TO: Josh Parker, Planning Officer, Haringey Council

FROM: Perna Chainani & Thor Monsen, 93 Wood Vale, London N10 3DL

SUPPLEMENTARY OBJECTION FROM NO. 93 WOOD VALE RE: HGY/2023/2174

Figure 4: No. 93 Living Room Window

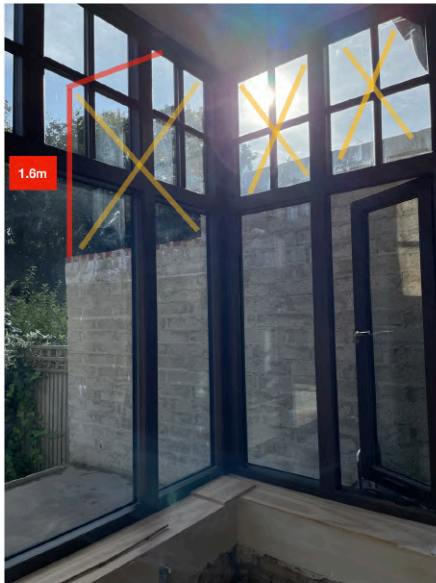
- a. Fig. 4 (left) shows the extension completely blocking the main source of afternoon and evening light to our living room & kitchen. Our terrace and garden would also be overshadowed. Photo taken at 3pm on October 8th, after which sun sits lower and tighter until Spring, making it even more vital that this clearance is not obstructed.

- b. This source of light is well established and the terrace wall on this side was specifically re-built to the height of the original in order to retain this access to light. We have historic photographs to show the same.

- c. This window is also the only source of cross ventilation on our West flank, providing a key **sustainable Passive Ventilation** solution for our home, as per the **London Plan cooling hierarchy**. Obstruction risks creating a **'heat island effect'**, blocking airflows and removing the **cooling and drainage benefits of nearby trees and greenery** (DM21: Sustainable Design, Layout & Construction).
